Craiginmoddie Wind Farm Additional Information - Main Report

Energiekontor UK Ltd

October 2021

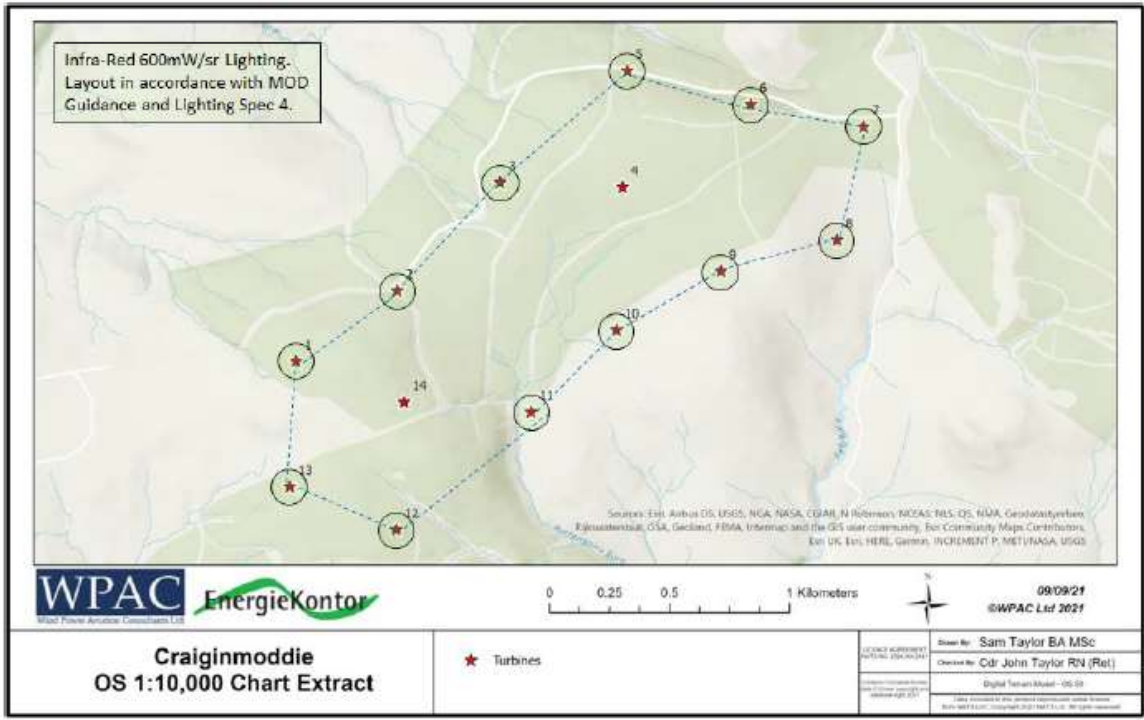
- 2.27 Applying these criteria dictates that all of the twelve perimeter turbines of the Craiginmoddie site would require ANO visible red lighting. This is shown on Figure 2 (CAA-ANO CAP 764 Compliant Lighting Arrangement) of the Report reproduced below.

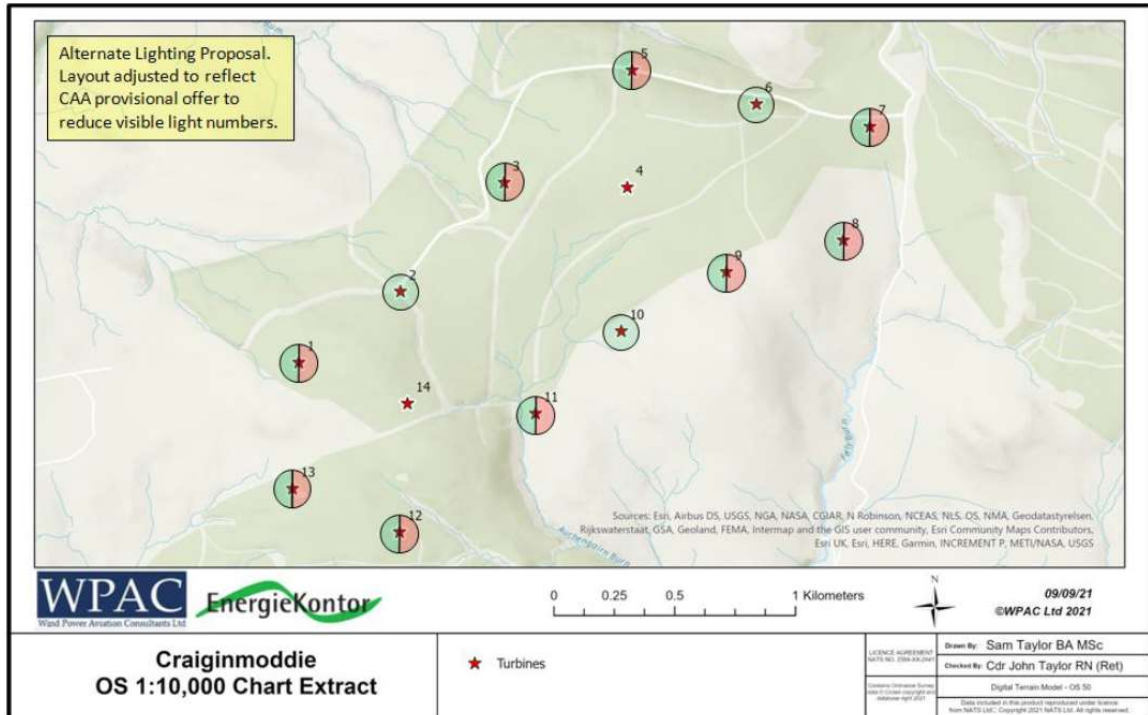
2.28 In addition, the Ministry of Defence (MOD) will require the turbines to be lit with infrared lights (IR) that can be seen by military pilots operating on night vision goggles. The resulting lighting scheme proposed for Craiginmoddie Wind Farm in relation to IR is shown on Figure 4 (MOD IR Guidance Compliant Lighting Arrangement) of the Report as reproduced below. The MOD have confirmed that the aviation lighting scheme meets the laid down requirement of the MOD and therefore have no concerns (see **Appendix 2.4.1**).

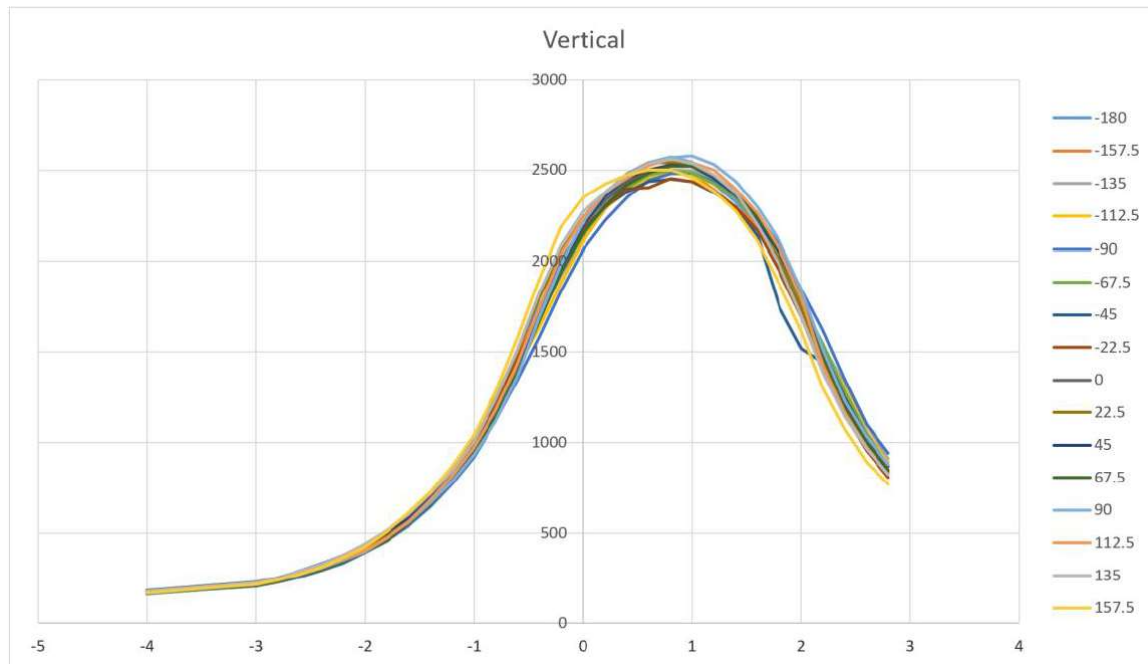
- 2.29 Detailed discussions have taken place with the CAA and this has indicated that the ANO lights on Turbines T2, T6 and (T10 or T9) can be removed provided that resultant light spacing is kept no greater than as currently proposed. This is shown in Figure 8 of the Report, reproduced below

- 2.33 Calculations have been undertaken for each designated lit turbine against all Craiginmoddie viewpoint locations utilising the reduced turbine lighting layout shown in Figure 8 of the WPAC Report (and above). The candela figures radiated toward a viewpoint, taking into account the distance and a calculation of the lumens per square meter that would be experienced by the human eye at the viewpoints are set out at paragraph 16 of the WPAC report for each viewpoint. These figures are for perfect clear-air figures and therefore the worst case scenario from LVIA perspective. In practice the light intensity at the viewpoints will be further attenuated by scatter and absorption by airborne dust, droplets and aerosols in the atmosphere.
